At: 11 - these are for the Lockhart #8 SWD
for Chevron.
Thanks Carolyn Saunier
432-687-7261

After reviewing your application, I have the following comments and requests:
1) Is S&D Ranch the surface owner? Our system says that the surface is Fee and the subsurface is Fed near this wellbore

SWD Application: CH Lockhart NCT-1 #8, API: 30-025-12131

WELL DATA SHEET

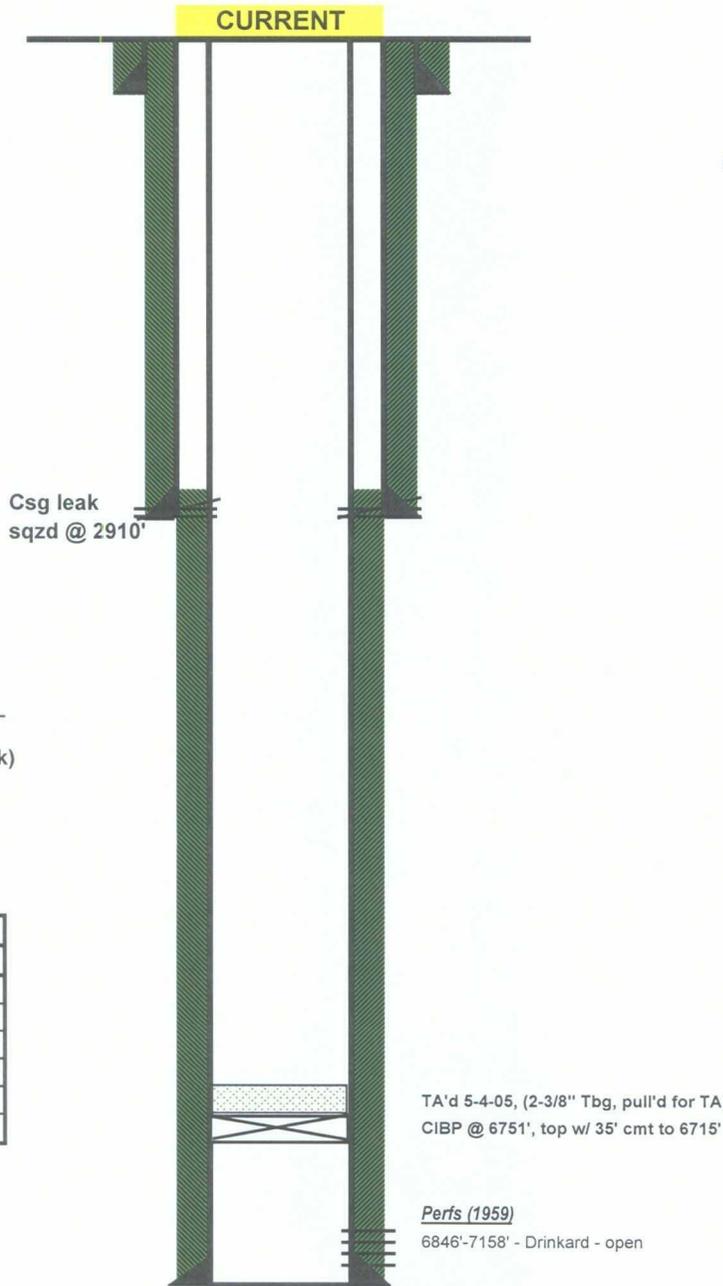
I really liked your wellbore diagrams and the data you put on them - thank you. Let me know what software you used?

WELL DATA SHEET

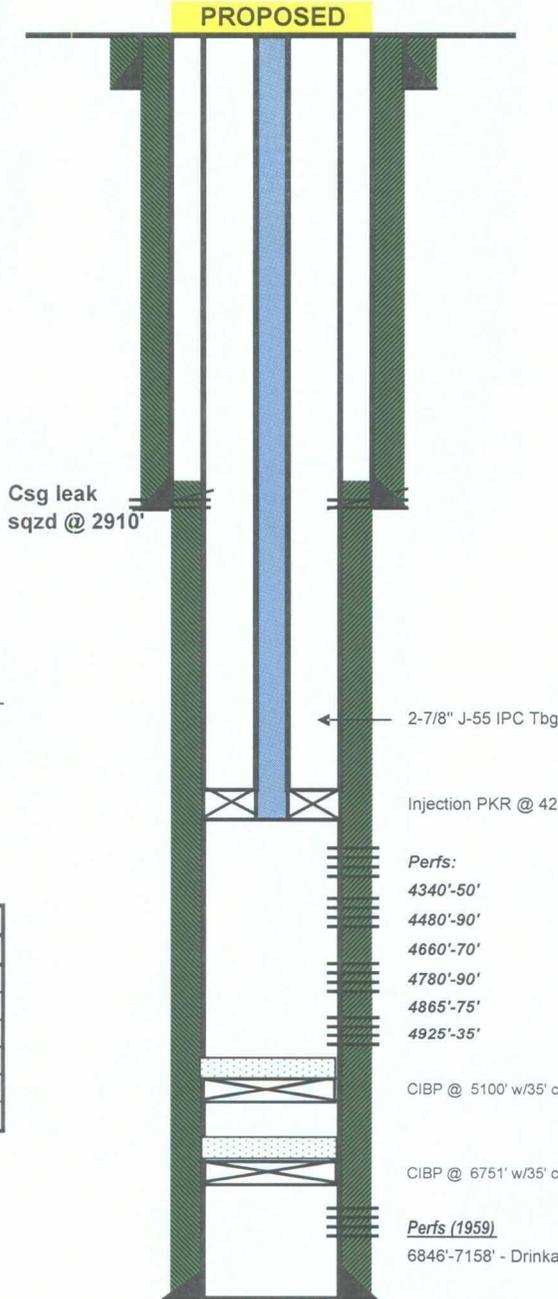
b) The permit will require another CIBP to be set within 200 feet of the lowermost injection perforation. However, if the well has already been perfed in the San Andres and tubing run, let us know?

See attached revised wellbore diagram.

CIBP @ 5100' w/35' cmt on top (5065')
